Access Compliance Report Public Rights-of-Way (Curb Ramps)

Main Street: LOS PATRONES PKWY Cross Street: COW CAMP RD Location: N

ADA ID: RPRK211130113356 Ramp Type: Type 1 - Perpendicular Initial Pass/Fail: Pass Overall Compliance: No Severity Score: 0

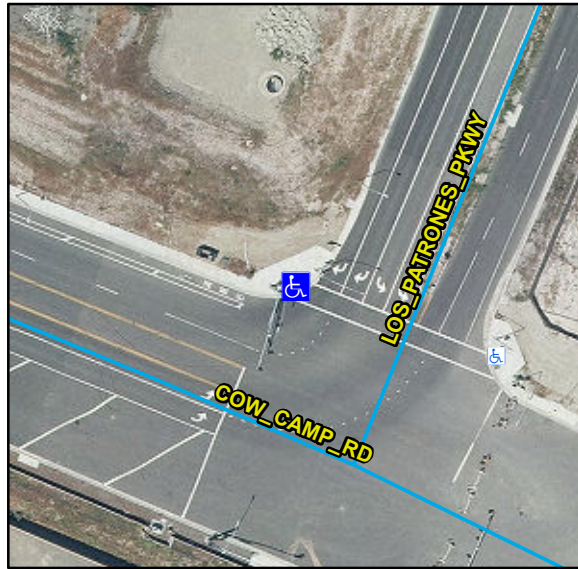
R304.2.2, R304.2.2-Perp, R304.3.2-Para, R207.1, STD 1115

No	Ramp Inside Crosswalk 1	No	Yes	Ramp Inside Crosswalk 2	N/A
	Crossing 1 Slope (%)	1.7		Crossing 2 Slope (%)	N/A
	Crossing 1 Cross Slope (%)	2.8		Crossing 2 Cross Slope (%)	N/A
Yes	Gutter Ponding	No	No	Curb Slope	10.4
Yes	Gutter Lip Height (in)	0		Road Run Slope (%)	N/A
Yes	Gutter Run Slope (%)	3.1		Road Cross Slope (%)	N/A
Yes	Gutter Cross Slope (%)	2			
Yes	Overall Surface Condition: Acceptable		Yes	Perp Joint Present	Yes
	Cross Gutter Present?	No		Spandrel Present?	No
	Replace Cross Gutter?	N/A		Replace Spandrel?	N/A

Remove & Replace Entire Ramp. Restripe Crosswalk.
